# YOST GRUBE HALL ARCHITECTURE

# Addendum 1

То:	Megan Finch, Beaverton School District
From:	Allison Miller
Project:	BSD – Raleigh Park HVAC and Electrical Upgrades YGH Job #19-0012
Subject:	Addendum 1
Date:	16-March-2020

#### SHEET A2.10D – DEMOLITION FLOOR PLAN

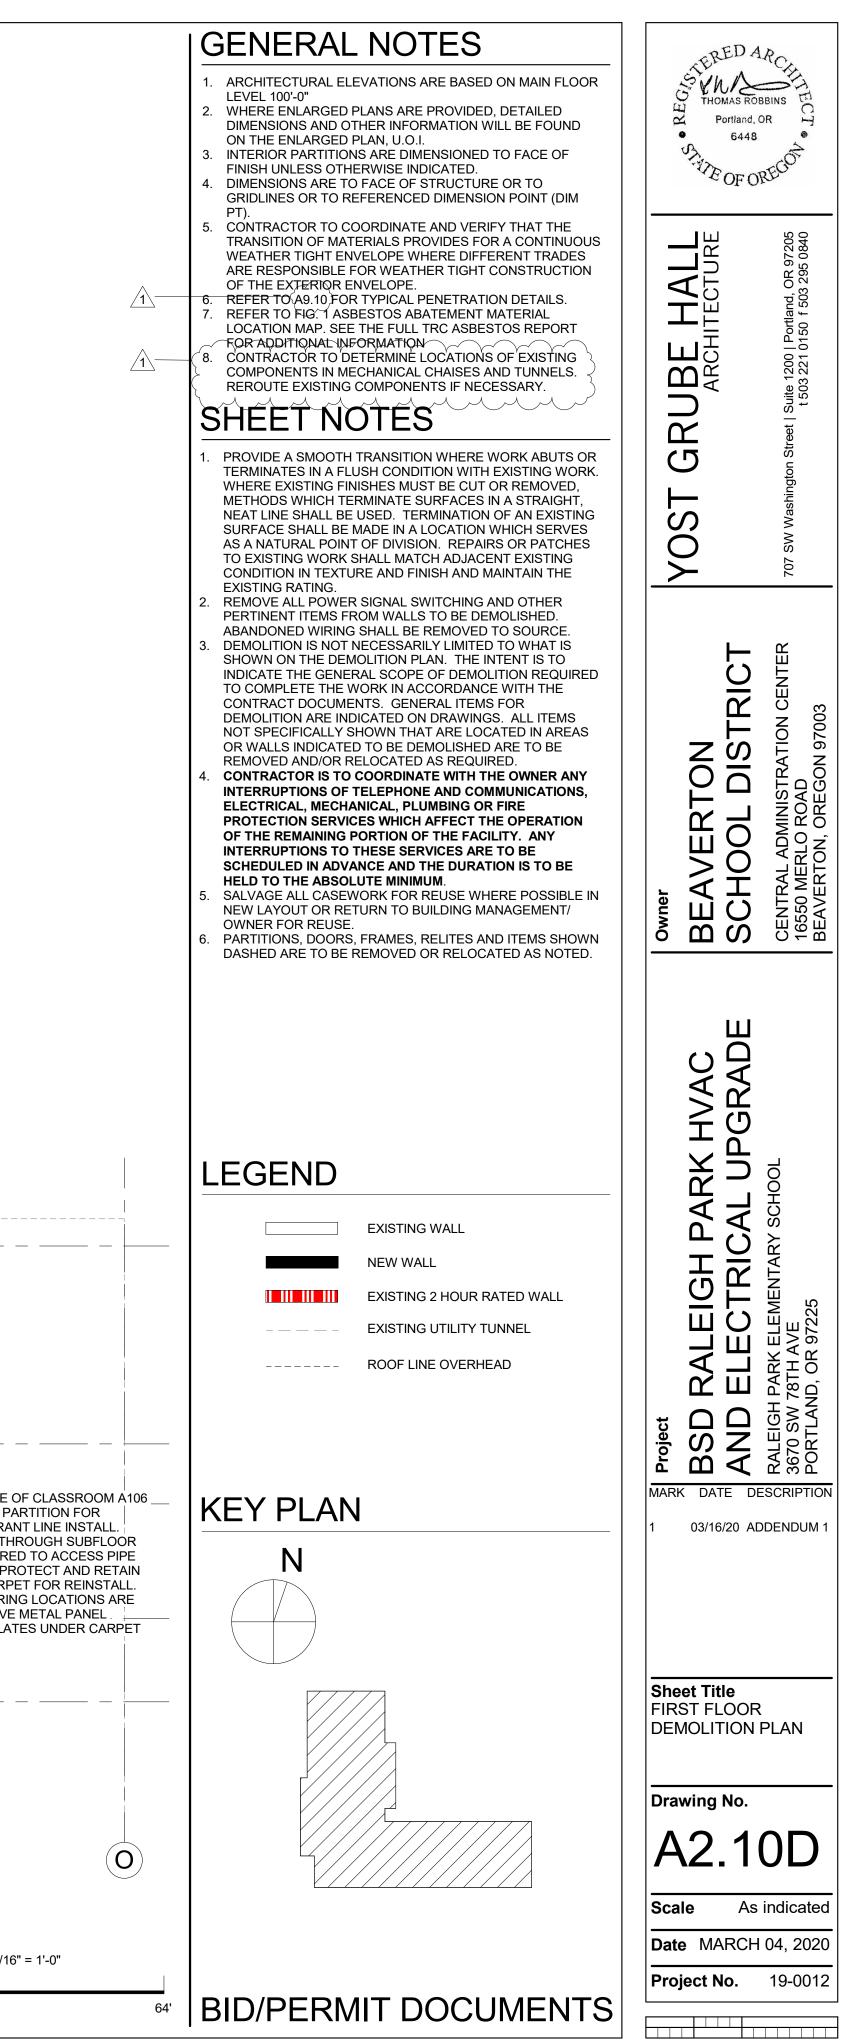
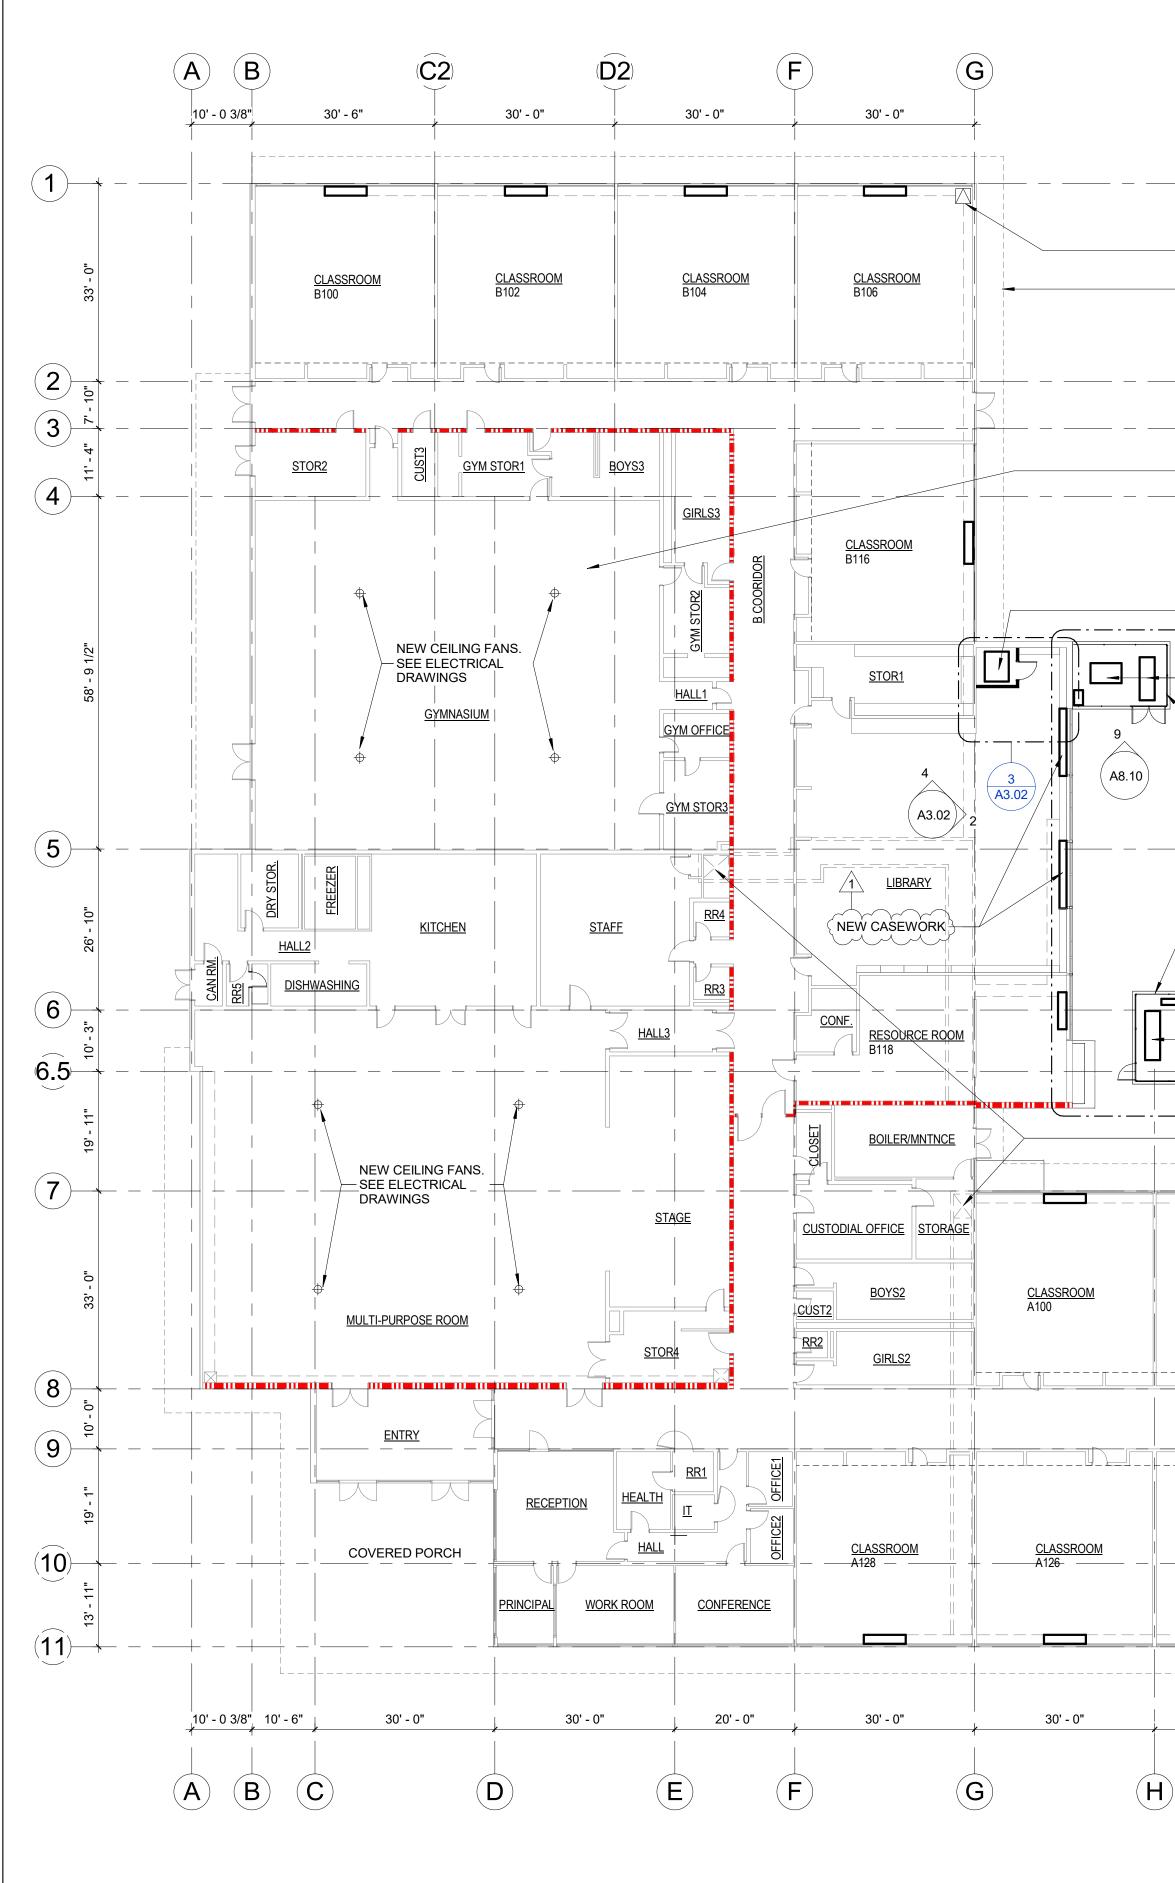
**ADD** note, clarifying relocation of existing fire alarm strobe and power wire mold in library (previously only called out from electrical drawings)

SHEET A2.10 - FIRST FLOOR PLAN

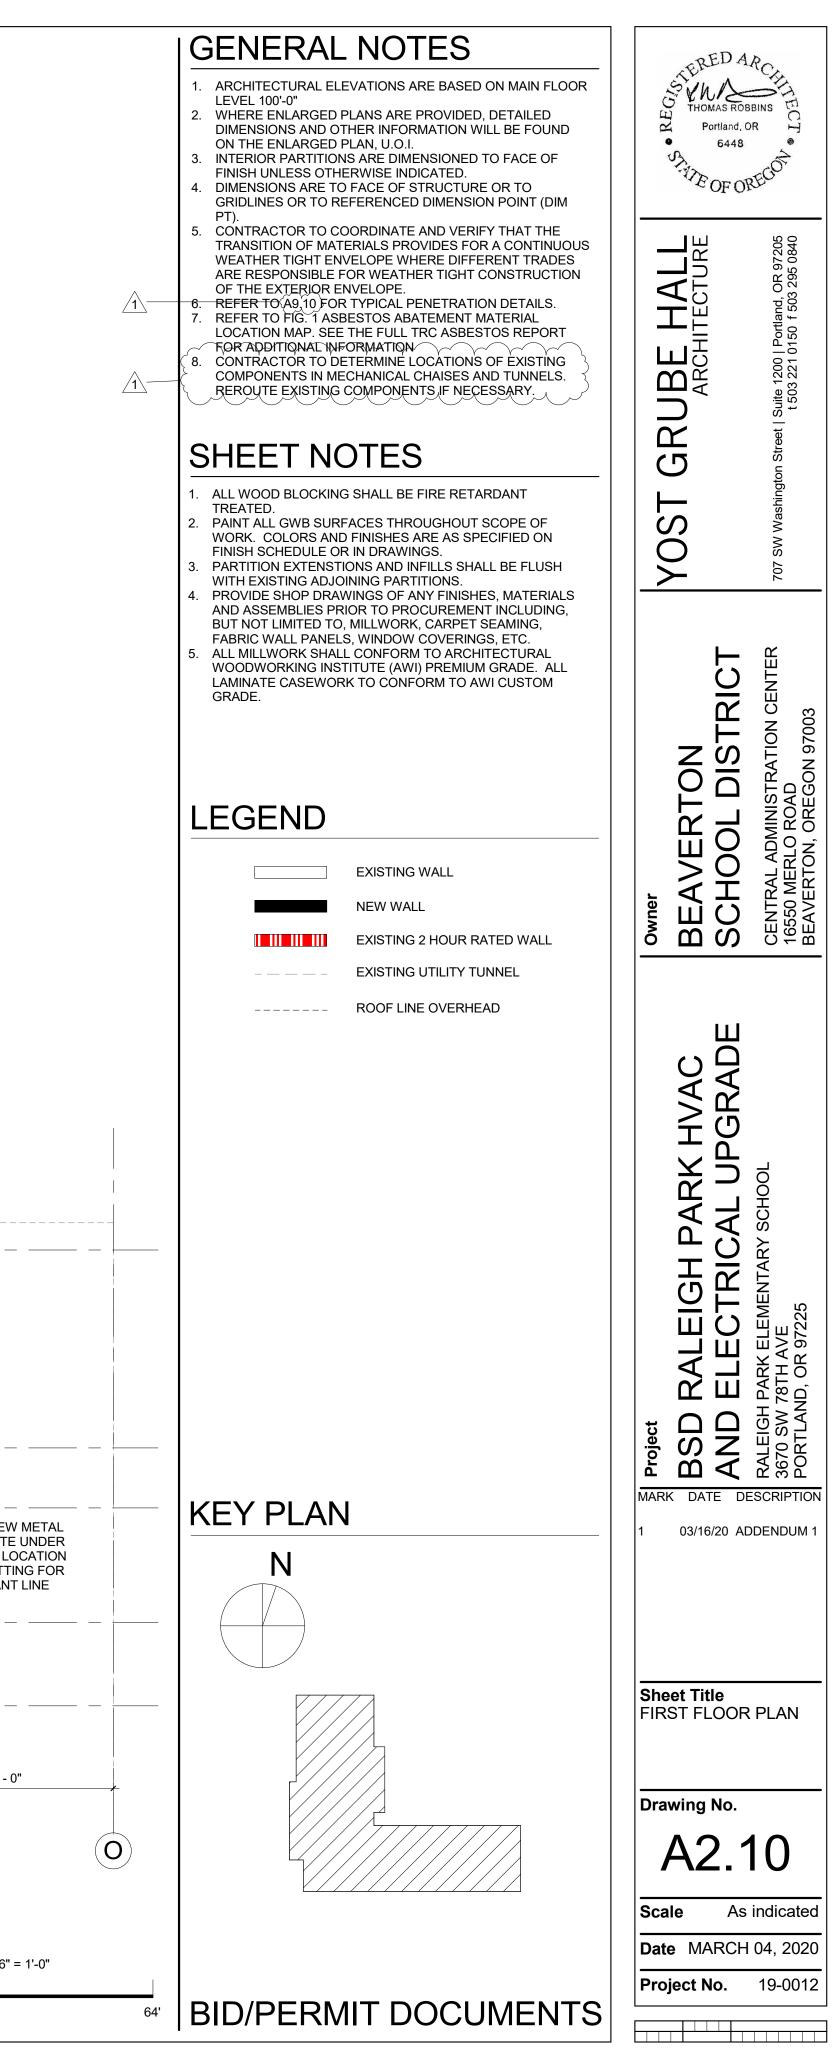
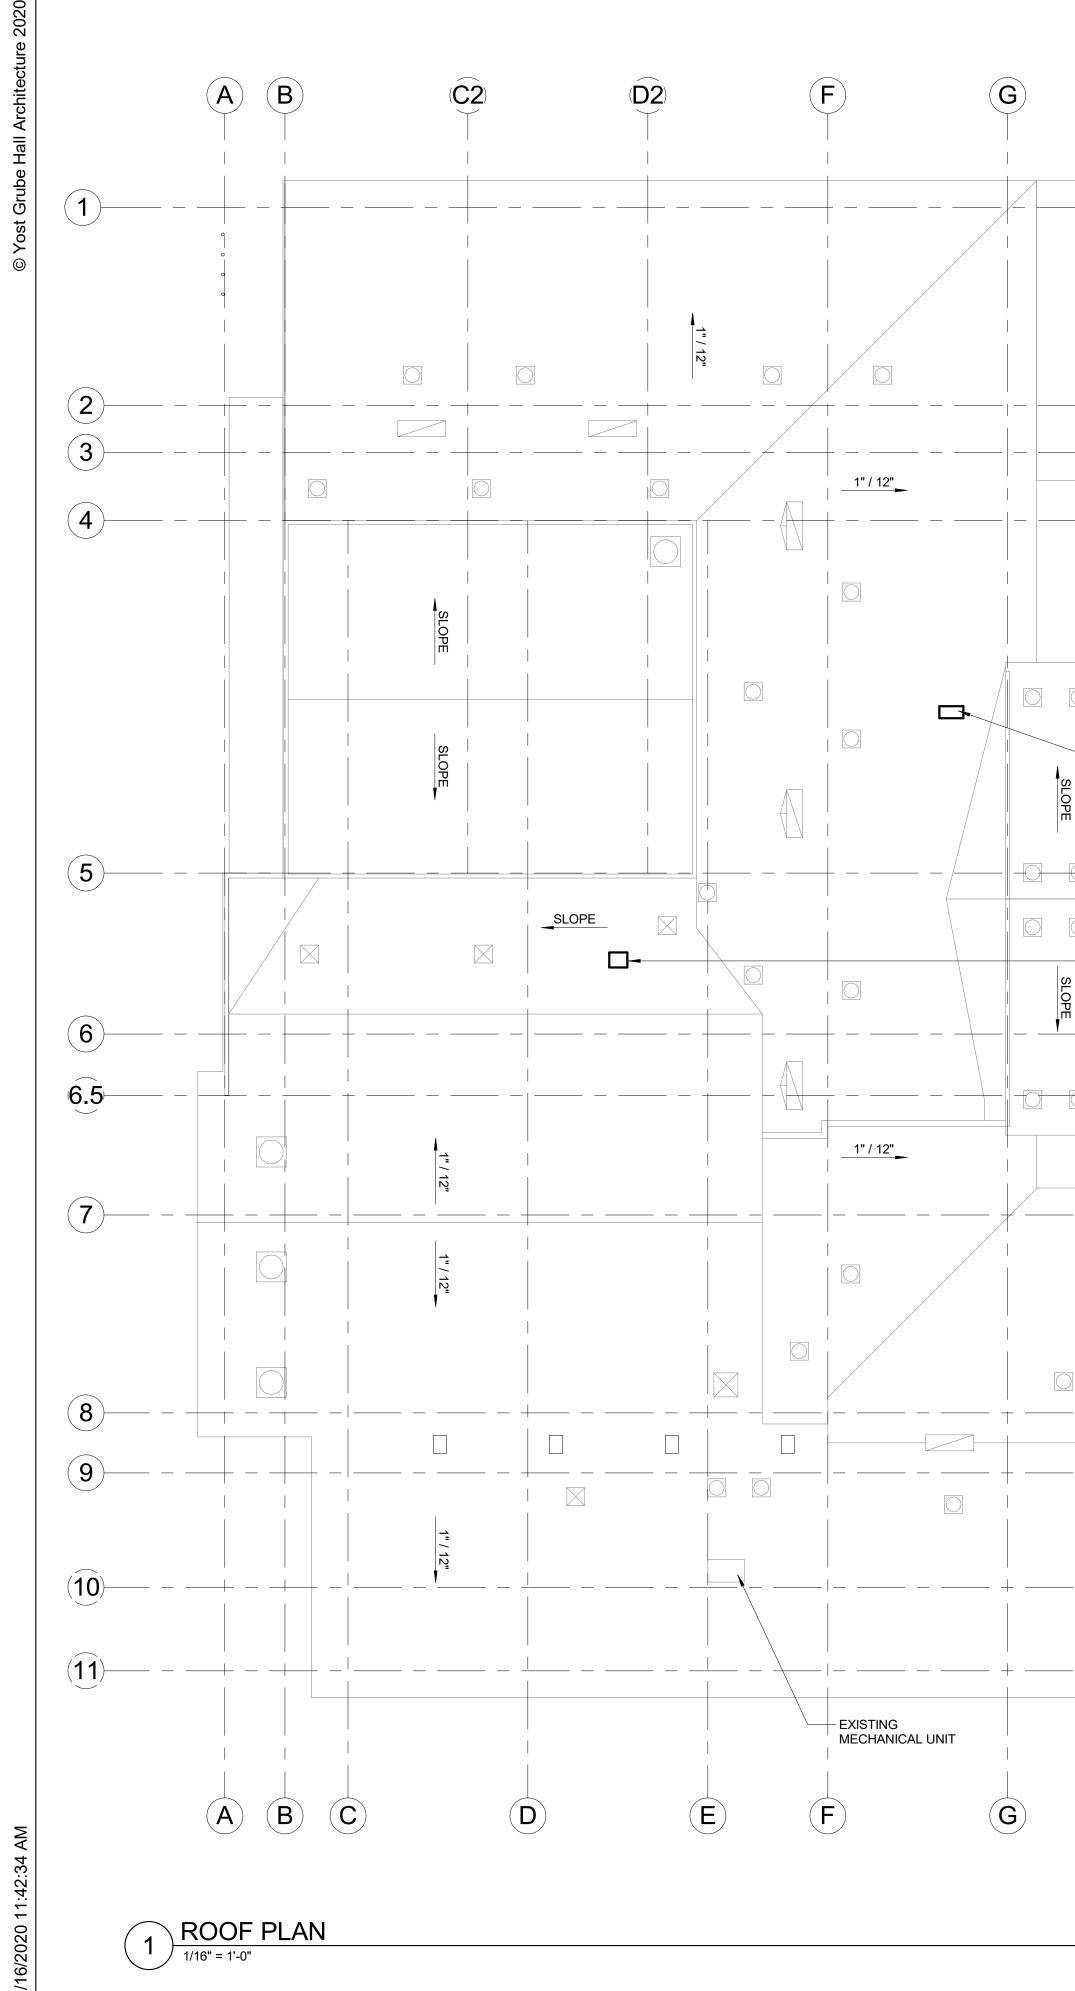
ADD general note #8

**REVISE** page reference for typical penetration details in general note #6 **ADD** note to clarify locations of new casework in library

#### SHEET A2.20 - ROOF PLAN

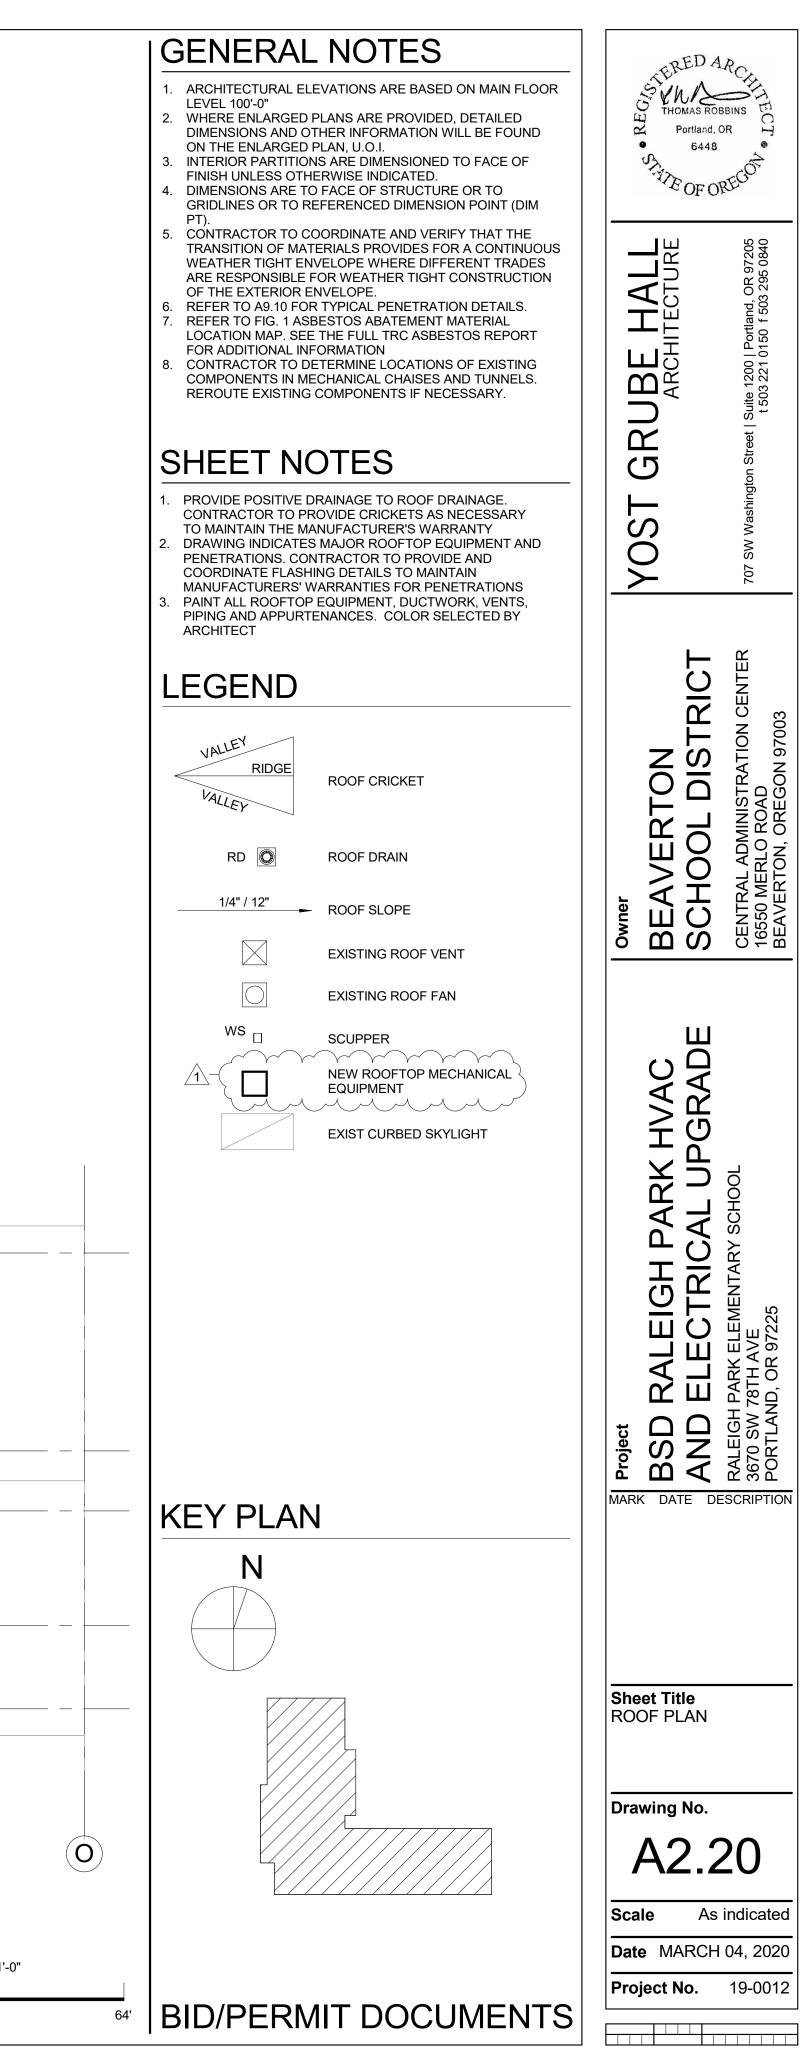
ADD new rooftop mechanical equipment to legend
